Our Ref : Cochlear Response to Agency Submissions

COCHLEAR LTD RESPONSE TO AGENCY SUBMISSIONS

Thank you for your recent comments in relation to the proposed development of the new Cochlear facility at Macquarie University. Following receipt of additional comments from the Department of Planning, Ministry of Transport, Roads and Traffic Authority and Ryde Council, we are pleased to provide you with the following consolidated response.

Ryde Bicycle Strategy and Masterplan
Map 8 Proposed bicycle network connectivity
Version 1 May 2007

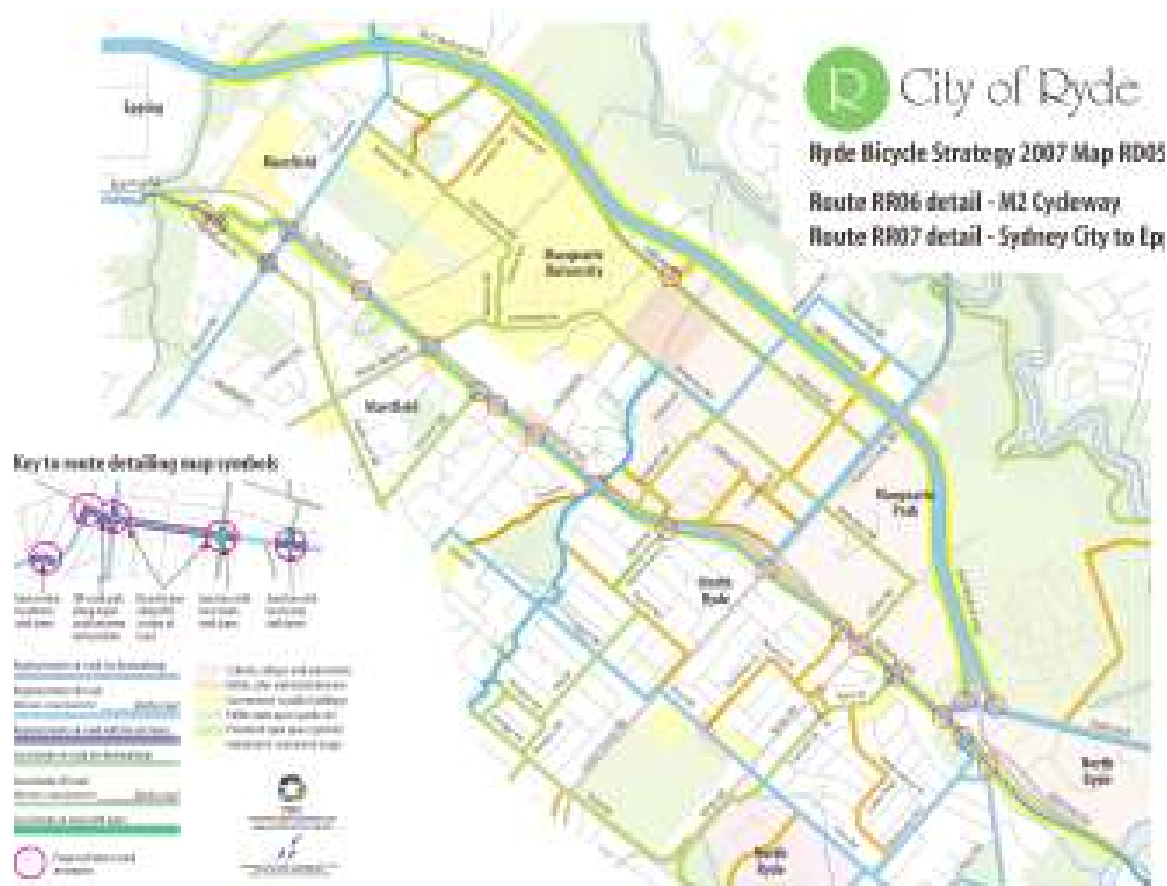
- RTA2:** *Implement Travel Demand Management initiatives (ie: carpooling, tele-working, etc) to reduce demand for car parking and traffic generation.*
- MoT1:** *The Director General's Requirements include the need to consider measures that promote a modal shift to public transport. The environmental assessment does not adequately address this requirement by not identifying a sustainable mode share target for the proposal or a package of discrete measures that can realise a successful shift in mode share to public transport;*
- MoT2:** *The draft Macquarie Park Traffic Study recommends a mode share target of 40% to public transport together with walking and cycling within the Macquarie Park corridor, which includes the University. The Ministry therefore recommends that further mode share analysis of the proposal be completed using current 2006 Journey to Work Census data;*

Further consideration will be given to the installation of a pedestrian and cyclist wayfinding system which would comprise directional signage from the rail station, bus interchange, campus facilities, shopping to from/Cochlear. Signage to direct cyclists from local University cycle paths onto strategic routes (as shown in the City of Ryde Proposed bicycle network) would be implemented.

Figure 1 Ryde Local Environmental Plan No 137 - MPC Parking Restriction Plan (excerpt)

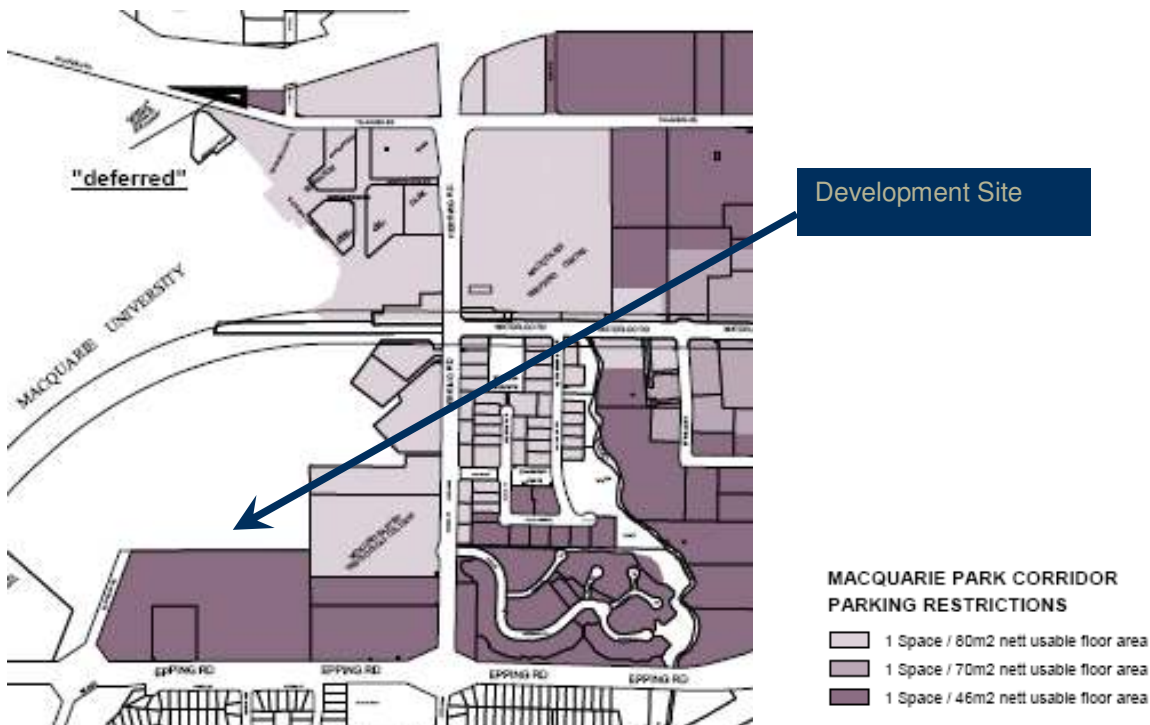
RTA7: *Carparking provision to the Department of Planning's satisfaction and provided in accordance with Ryde Council's DCP.*

The application of the current Ryde DCP 2006 Section 9.3 - Parking requires the provision of a minimum of 703 parking spaces for the Cochlear development. This however, differs from the parking restrictions as set out in Ryde LEP 137. The subject site falls within the area identified to be included in the Draft DCP and the Macquarie University Concept Plan. The Draft DCP states that car parking for commercial and industrial activities is to be provided for in accordance with the rates contained in the Ryde Planning Scheme. The Ryde Planning Scheme Ordinance indicates that off-street parking requirements should be in accordance with LEP 137.

The proposed project site is not included in the Macquarie Park Corridor Parking Restrictions Plan provided in LEP 137. Refer to Figure 1.

It is considered that applying the parking rate applicable to the area immediately to the south of the subject site (1 space per 46m²), as indicated in LEP 137, would be applicable to this site and therefore appropriate for use in calculating maximum parking provision.

Figure 2 Suggested Early Implementation Works - University Avenue Segregated Bike Path

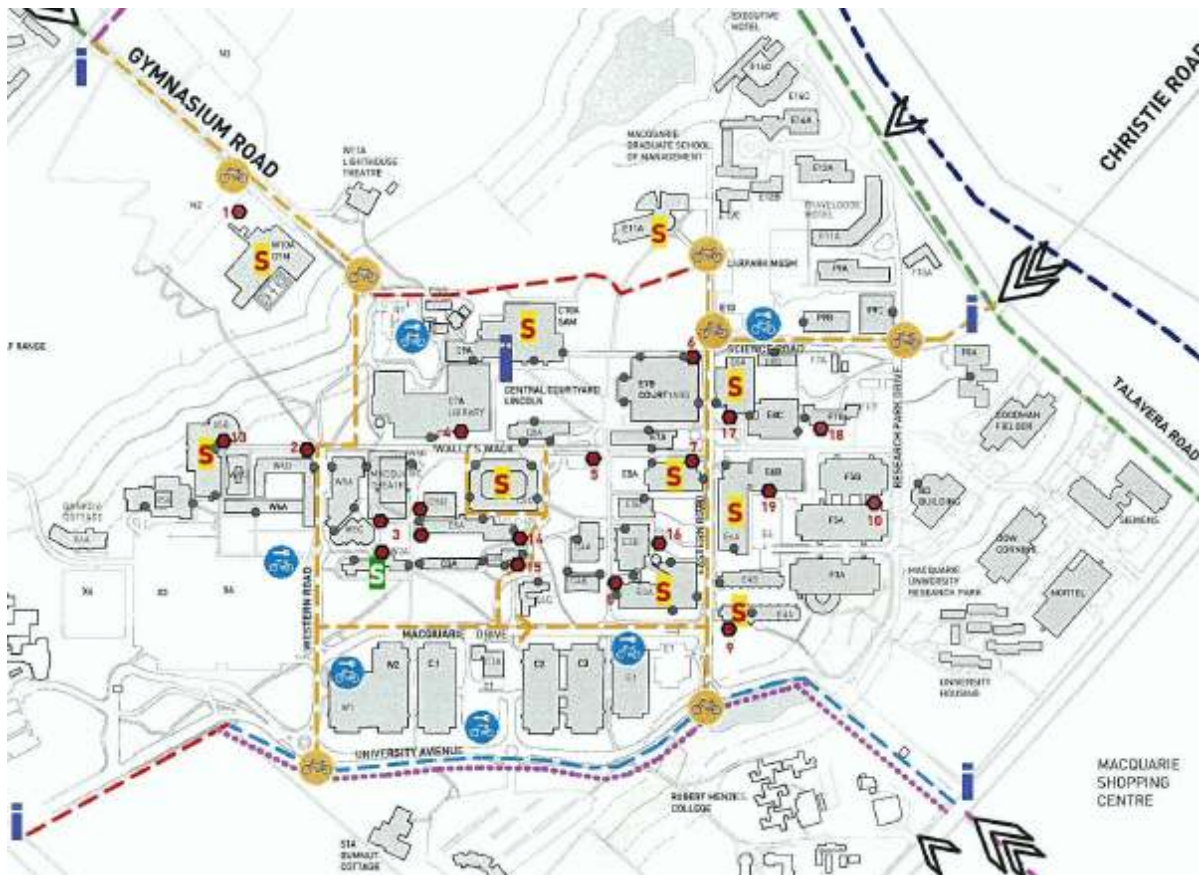
MoT6: *The provision of cycle access to the subject site along University Avenue is not clear within the proposal. Given the high level of proposed bicycle parking a more detailed design approach is required, which builds on the Macquarie University Concept Plan.*

To assist staff to use sustainable travel from the first day of occupation, consultation will be undertaken with MQ regarding the early implementation of the proposed off-road segregated bicycle path along University Avenue as shown in Figure 7.2 Short Term Option of Macquarie University Bicycle Network Masterplan see Figure 1.

The proposed bicycle paths include:

- Proposed 2.5m wide off-road two-way segregated cycle path connecting the Balaclava Road and Waterloo Road intersections; and/or
- University Avenue Roundabouts - proposed green surfaced bicycle lanes at the two roundabouts on University Avenue to highlight the presence of cyclists at this location and provide further protection for cyclists accessing the University.
